## REMARKS

**Attachment:            Replacement Sheet**  
**Annotated Sheet Showing Changes**

ATTY DKT. No.: APPM/007874/CPI/ALD/PJS  
U.S. SERIAL No.: 10/644,598  
FILED: AUGUST 20, 2003  
APPLICANT: APPLIED MATERIALS, INC.  
TITLE: ELECTRONICALLY ACTUATED VALVE  
INVENTORS: NGUYEN, ET AL.

FIGURE 1

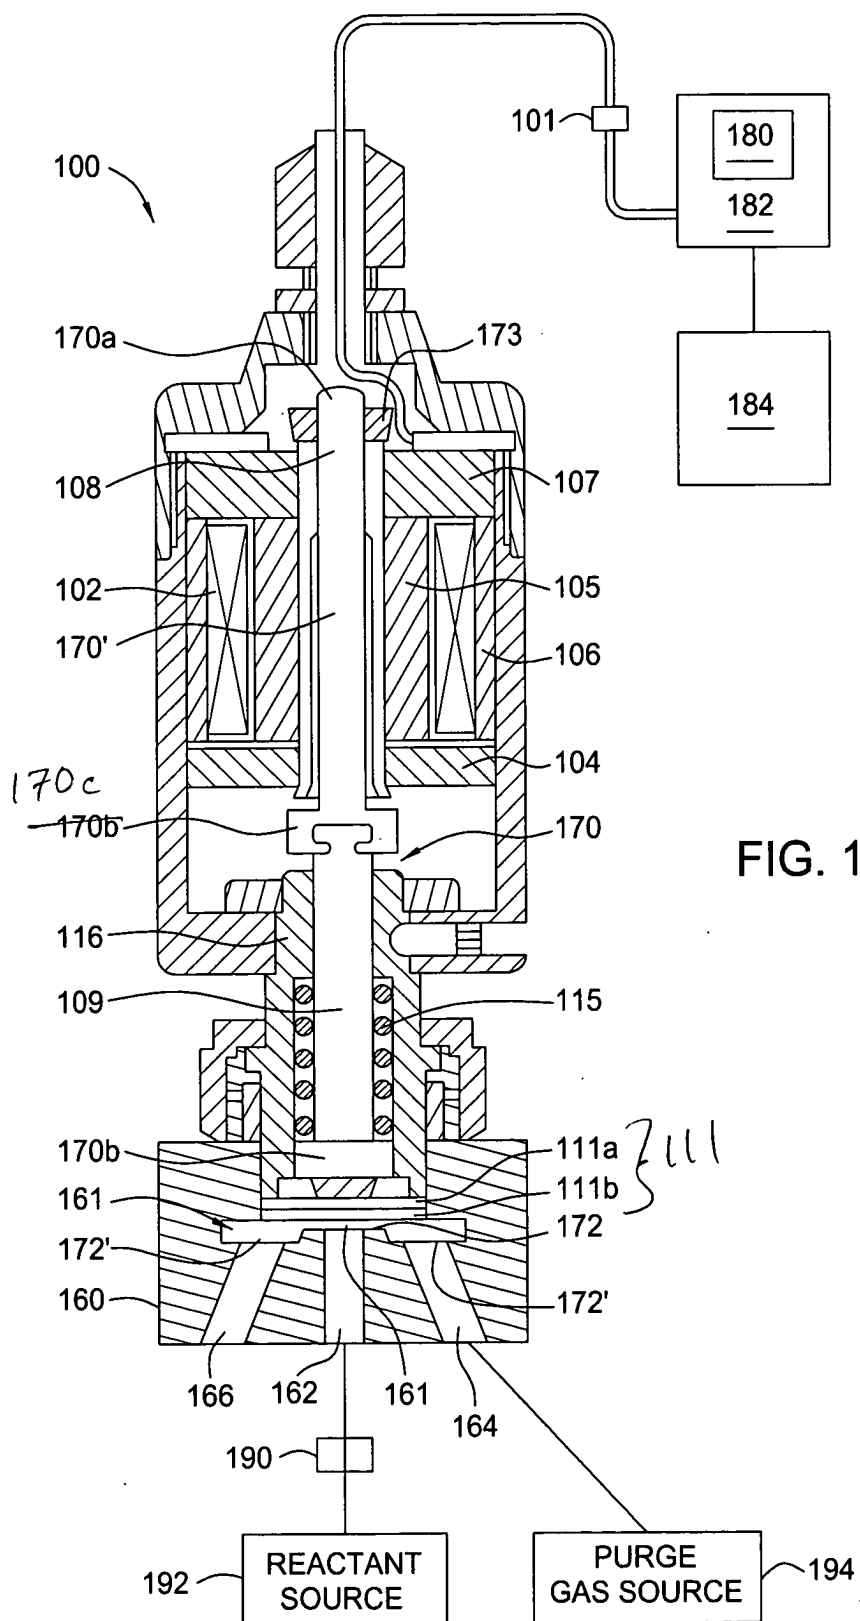
In amended Figure 1, the previously omitted element numeral 111 has been added. In Figures 1 and 2, one occurrence of reference numeral 170b has been amended to 170c. No new matter has been added.

Applicant acknowledges the objection to the drawings where the Examiner asserts that the solenoid coil [102] is not shown being attached to the piston [170']. Applicant respectfully traverses the objection and submits that the feature is shown in Figures 1 and 2, absent amendment. Applicant submits that Figures 1 and 2 are generic and one skilled in the art will realize that the solenoid coil [102] may be attached to magnet [107], which may be attached to the movable shaft [108]. Applicant respectfully requests that the objection to the drawings be withdrawn.

The attached sheet of drawings includes changes to Figs. 1 and 2. These sheets, which include Figs. 1-2, replaces the original sheets including Figs. 1-2. In Figure 1, previously omitted element 111 has been added and one occurrence of 170b has been changed to 170c, to coincide with the description of the Figure. In Fig. 2, as in Fig. 1, one occurrence of 170b has been amended to 170c. Applicant submits this was a clerical error and that no new matter has been added.
